PROJECT NAME:  
**LITTLE MOUNTAIN PV SOLAR POWER PLANT**

PROJECT ADDRESS:  
**S 7500 W ST  
WEBER COUNTY  
UTAH**

SHEET NAME:  
**OVERALL SITE PLAN**

SHEET #:  
**E-100.3**

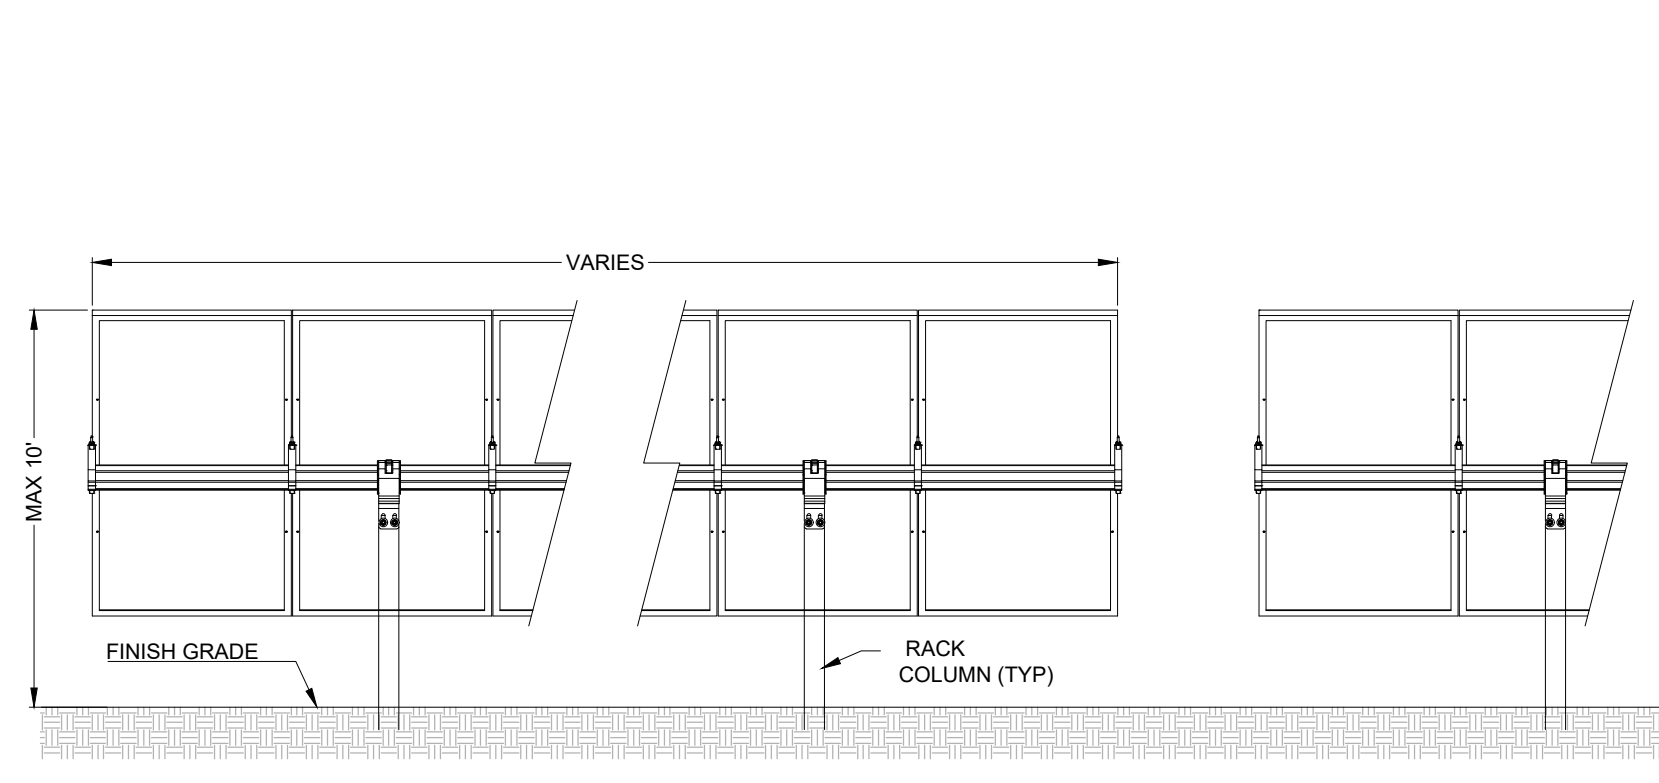
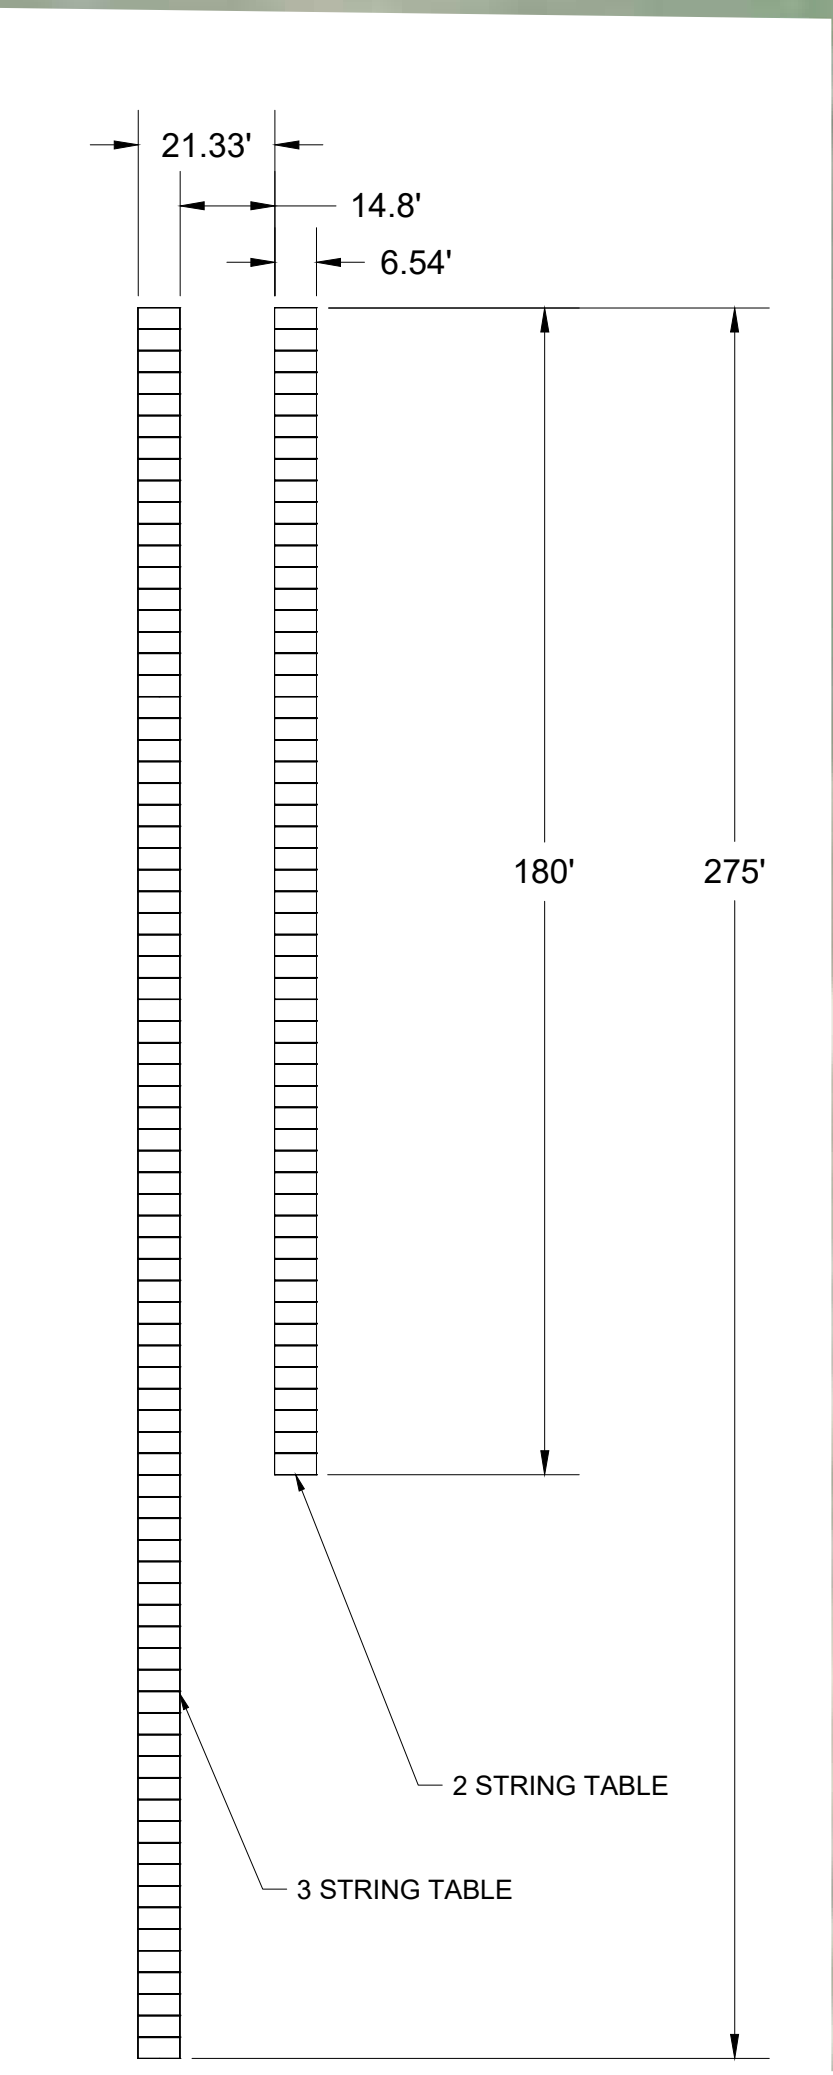
Please have them show the fencing material and height in a fence detail. If chainlink, I'm curious whether they would entertain a vinyl or powder coating that is a tannish/brownish earhtone that matches the ground in the area? This way we can avoid the shiny galvanized material that is visible for miles.

Please show the entire site boundary that is the subject of the rezone.

Can this be an asphalt approach? It will need to meet county standards for ROW construction. I will want an engineering cross section detail for the development agreement.

The legend show this as gravel. Can that be changed to all-weather roadbase with dust treatment?  
We will also want to see the detail of this in the development agreement.
